March 18, 2016

**Re: RAW Addendum  
Arsynco, Inc.  
Foot of 13th Street  
Carlstadt, Bergen County  
SRP PI# 024248  
ISRA Case # 93024**

FIGURE: 1

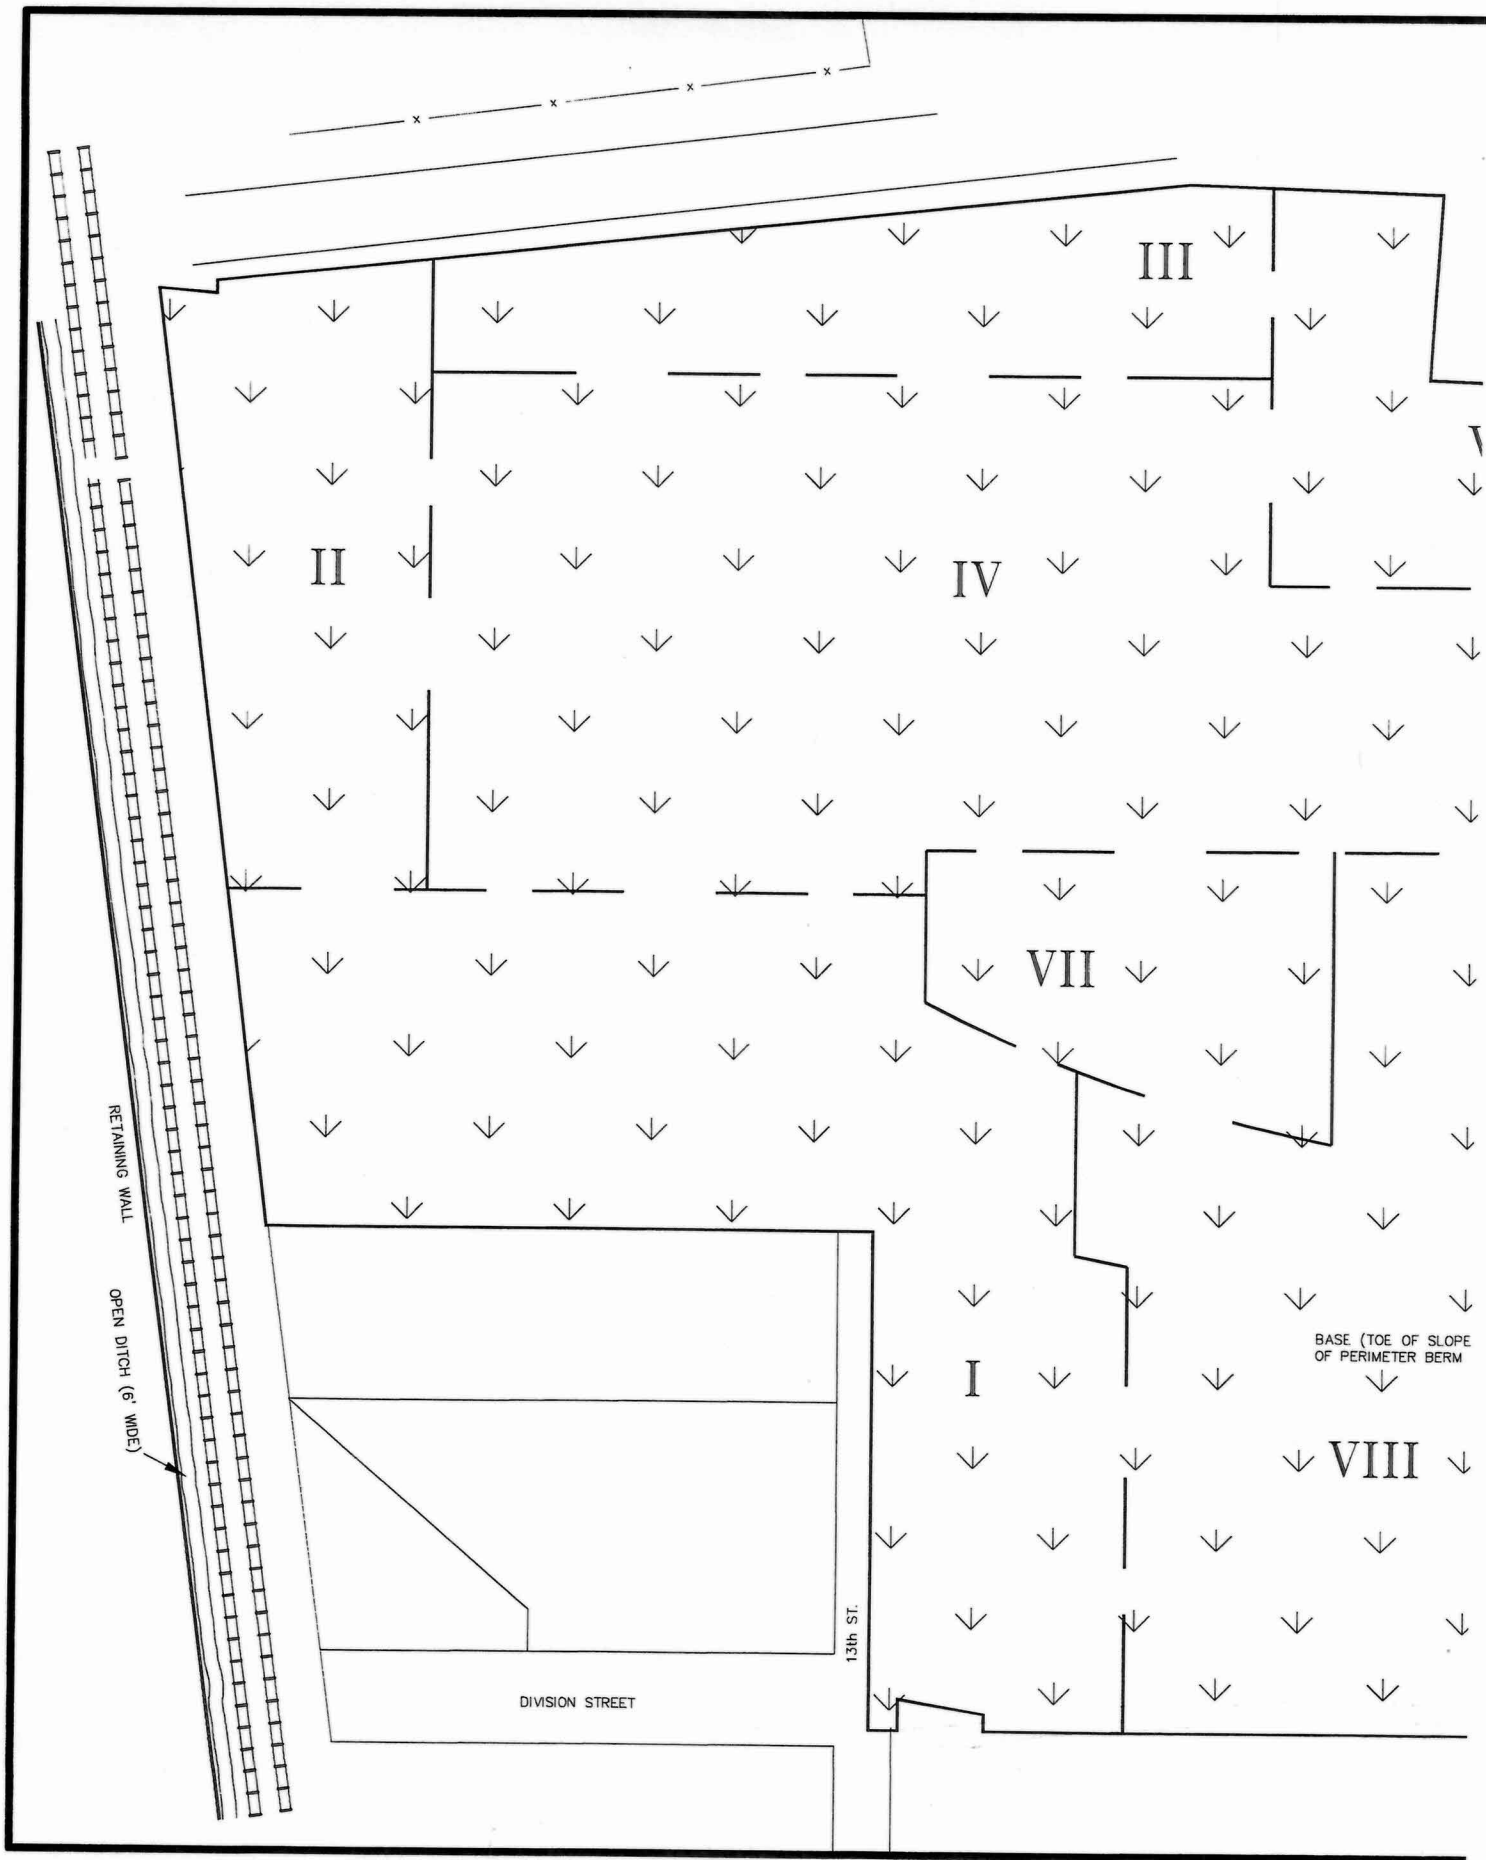
This RAW addendum is being submitted in relation to constructing a permeable cap in place of the previously approved asphalt cap across the majority of Tract 1 (excluding the TSCA disposal area). The proposed permeable cap would be 2 feet thick and consist of certified clean fill covered by up to 6 inches of either certified clean top soil with vegetation cover or gravel. A permeable separation/demarcation

layer to provide a visible indicator of the bottom of the cap. The cap would be compacted to reduce settling, and the top soil cover areas would be vegetated (seeded for common grasses typical to region of site that are low maintenance and draught resistant) for further stability and control of erosion. The top soil and vegetation cover would be used in most areas, but a surface gravel layer would be required in certain areas of the site (e.g., site ingress/egress points, site access roads, parking areas, etc.). Tract 1 of the site is essentially flat, and the final grading with the permeable cap will have no slopes steeper than 3:1, which is preferential for erosion control. As required, routine inspections will be conducted, and general maintenance and erosion control will be conducted (O&M activities) under a Soil Remediation Permit. Proposed, long term engineering controls for Tract 1 also include maintaining perimeter fencing to prevent unauthorized entry onto the site, and future use of the site will be limited to non-residential. The permeable soil/vegetation cap will mitigate exposure to potential receptors and will be protective of human health and the environment. The extent of the proposed permeable soil/vegetation cap is shown on Figure 1 (attached).
